INSTRUCTION TO SERVICE

ITS: 58779	
SECTION:	292 Electrical Harnesses
WRITTEN BY:	Kristian Melo
SUBJECT:	Rewire TRW steering column to provide a memory power circuit

ITS58779

Figure 1: Emergency Power Switch Location

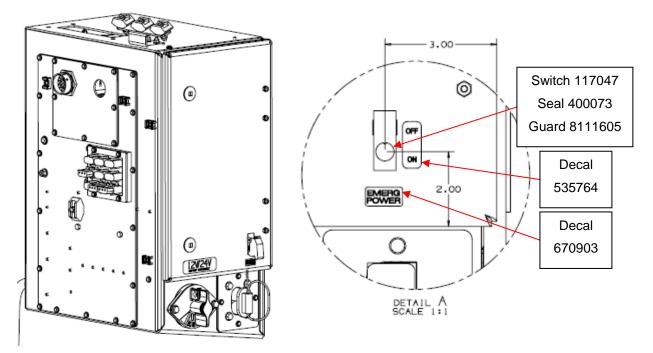
- 1) Turn the main battery disconnect switch to the "OFF" position.
- 2) Locate the fuse box assembly.
- 3) Drill a hole 0.5" in diameter into the front door of the fuse box for the new emergency power switch. Exact location shown in Figure 1 below.

Figure 3: Location of 10-24UNC Hole for Fuse

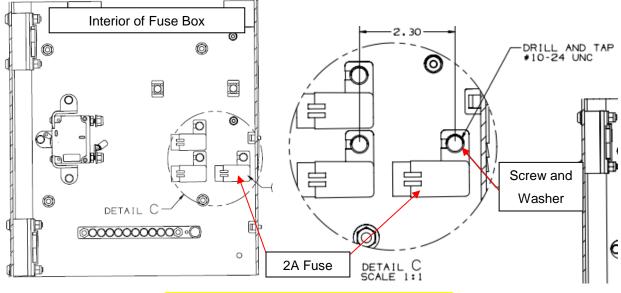
5) Drill and tap 10-24UNC hole on the interior of the fuse box. Details shown in Figure 3 and 4.

Figure 4: Fuse Box Connection Locations

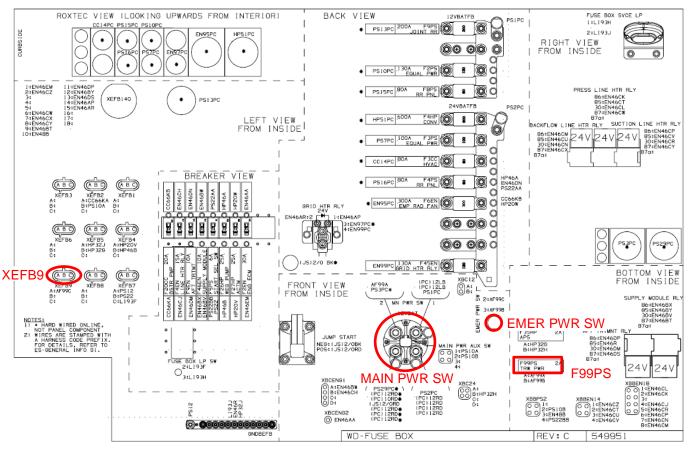
- 6) Secure the provided 2A fuse (PN: 198196) to the inside of the fuse box using the hole drilled in step 5 and the provided screw (PN: 14S00006) and washer (PN: 659000).
- 7) Locate wire 36SPR36G in the engine fuse box.
- Apply provided socket (PN: 102879) to 36SPR36G and load 36SPR36G into cavity A of XEFB9 (PN: 104043), shown below in Figure 4, using the provided connector seal (PN: 102877) to seal open cavities.

- 9) Secure wiring neatly along routing paths using tyraps (PN: 5958112).
- 10) Locate and install HRNS-JMPR FUSE BOX (PN: 813086).
 - a) Identify wire 99PS99A. Terminate the appropriate end to terminal A of breaker F99PS (indicated in Figure 4) and connect the other end of the wire as indicated in Table 1.

- b) Identify wire 99PS99B. Terminate the appropriate end of the wire to terminal B of breaker F99PS and connect the other end of the wire to terminal 3 of EMER PWR SW (indicated in Figure 4).
- c) Identify wire 99PS99C. Connect the appropriate end of the wire to terminal 2 of EMER PWR SW and insert the other end of the wire to cavity A of the connector XEFB9-SHR.
- 11) Secure wiring neatly along the paths inside the paths with tyraps (PN: 5958112).

Figure 5: Side console panel with power relay and power resistor locations indicated.

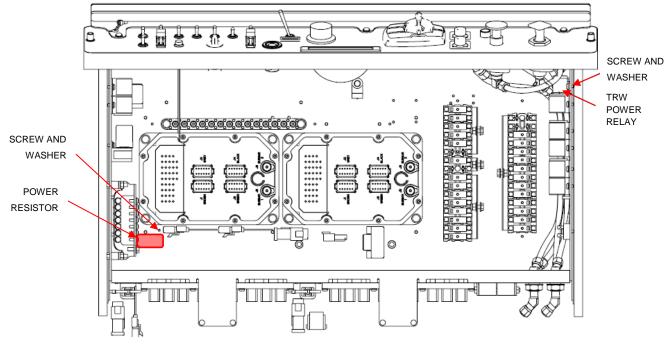
- Install this new relay assembly using the provided screw (PN: 14S00006) and washer (PN: 659000). This
 relay will be installed in the next position above the 24V relays on the right side of the panel, refer to Figure 5.

- 20) Locate the provided power resistor (PN: 627976). Using the provided screw and washers, (same parts as above) install below node 9. See Figure 5 below.

Figure 6. Side console with XSC4, XSC38, GNDBSC, and F20AF indicated.

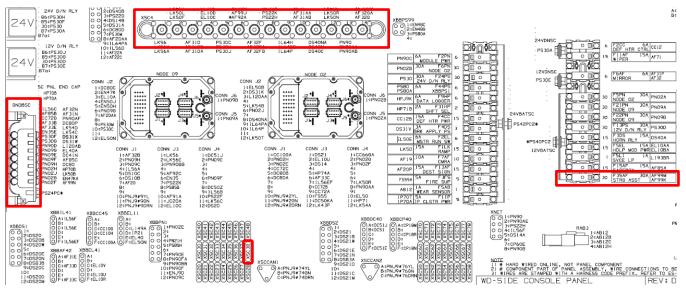
- 21) Locate the HRNS-JMPR SIDE CONSOLE PNL (PN: 813084) to be installed. Details shown in Figure 6.
 - a) Identify wire 99AF99G. Insert the appropriate end to cavity A of TRW PWR RESISTOR-SHR. Insert the opposite end to cavity A of connector XSC38-SHR.

- b) Locate wires PS80A, EN48G, and EN48C. Remove the wires from XSC4-6, remove terminals, and reterminate with provided socket (PN: 034794). Insert wires into splice bus (PN: 169346).

- i) PS80A to cavity 3
 - ii) EN48C to cavity 1
 - iii) EN48G to cavity 2
 - c) Identify wire 99AF99H. Insert the appropriate end to cavity B of TRW PWR RESISTOR-SHR. Connect the opposite end to position 6 of terminal strip XSC4.

- d) Identify wire 99AF99J. Connect the appropriate end to position 87 of TRW PWR RELAY. Connect the opposite end to position 6 of terminal strip XSC4.

- e) Identify wire 99AF99N. Connect the appropriate end to position 85 of TRW PWR RELAY. Connect the opposite end to GNDBSC.
 - f) Identify wire 99AF99M. Terminate the appropriate end to position 86 of TRW PWR RELAY. Terminate the opposite end to terminal 2 of breaker F35AF.

- g) Identify wire 99AF99K. Terminate the appropriate end to terminal 30 of TRW PWR RELAY. Terminate the opposite end to terminal 2 of breaker F35AF.
- 22) Secure wiring neatly along the paths inside the paths with tyraps (PN: 5958112).

Figure 7. Rear bulkhead with connector XBHR3 indicated.

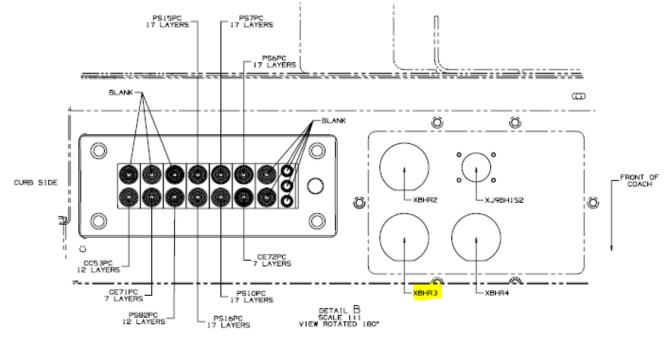
- 23) Locate XJ21 at the joint.
- 24) Identify wire 21SPR21C terminated with an end cap at the joint. Cut and trim the wire and then re-terminate with the provided socket (PN: 102879). Insert the wire into cavity 3 of the connector XJ21 at the joint bulkhead.
- 25) Locate XBHR3 at the rear curbside bulkhead shown below in Figure 7.

- 26) In connector XBHR3, locate 21SPR21C and 21SPR21D.
- 27) Swap 21SPR21C in XBHR3-16 with 21SPR21D in XBHR3-14.
- 28) Secure wiring neatly along routing paths using tyraps (PN: 5958112).
- 29) Install provided side console and fuse box decals.
